Crossroads Logistics Center Additions

SP-2021-0169D

Variance Request

Variance recommendation

Retaining Structure

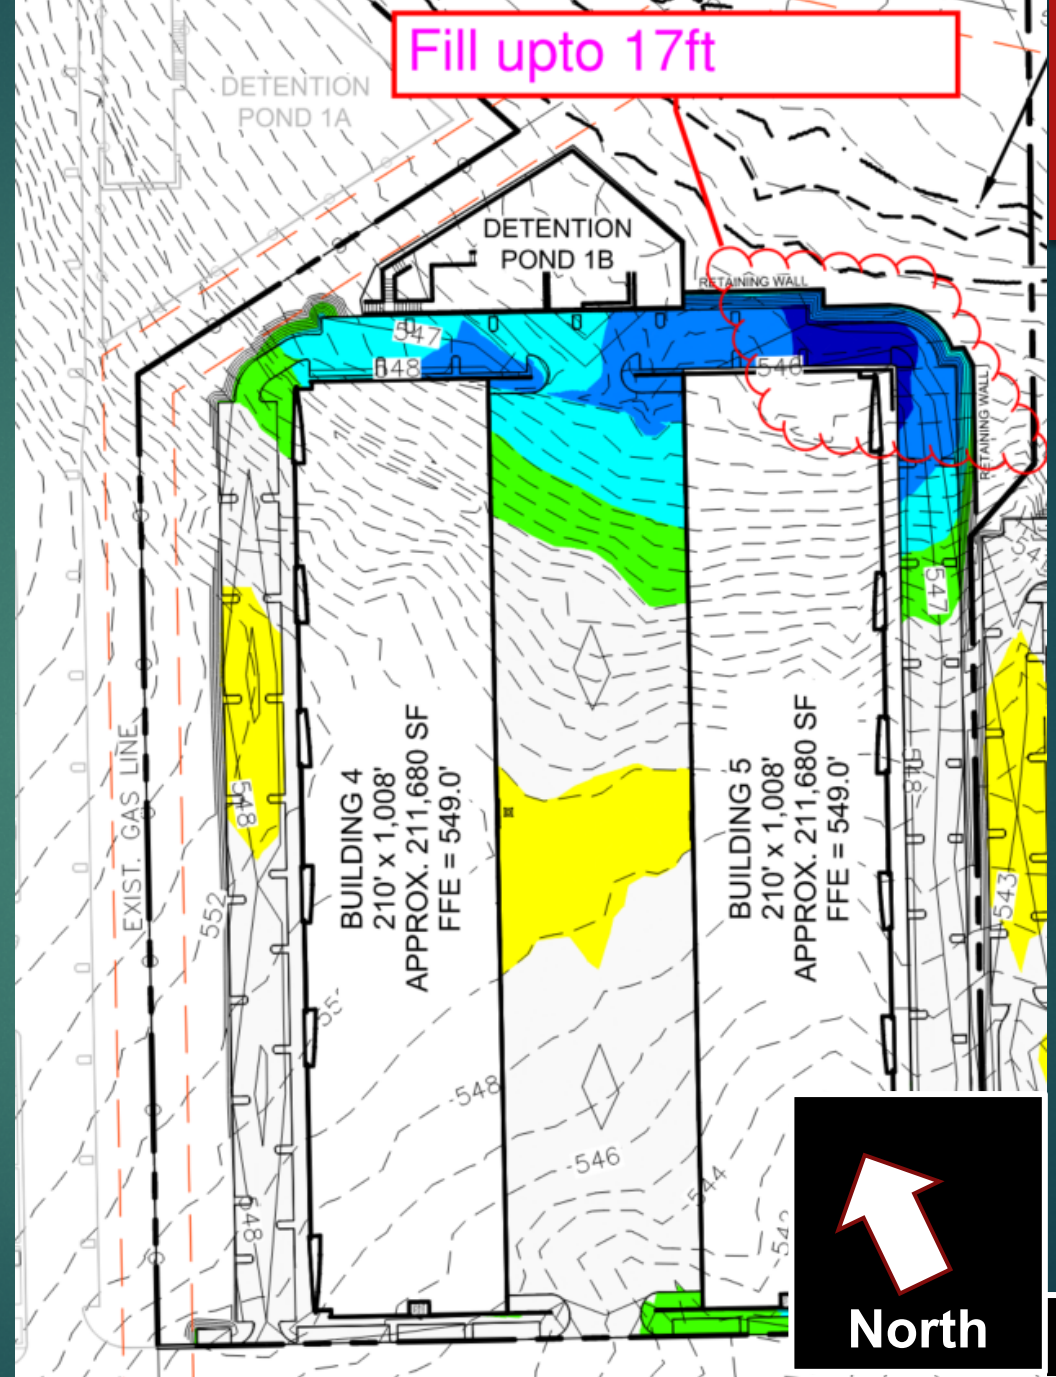
- To structurally contain fill and minimize the amount of grading
- Resist lateral pressure of the soil.
- Prevent movement of soil downward.
- Enhancing stability.

- Increase setback area by a minimum of 1.09acre for existing CEF.
- Preserve trees (not required in the ETJ)
- Apply City of Austin Landscaping Ordinance (not required in the ETJ)
- Increase tree inches on site/mitigation (not required in the ETJ).
- Provide structural containment of fill with a retaining wall (552lf).
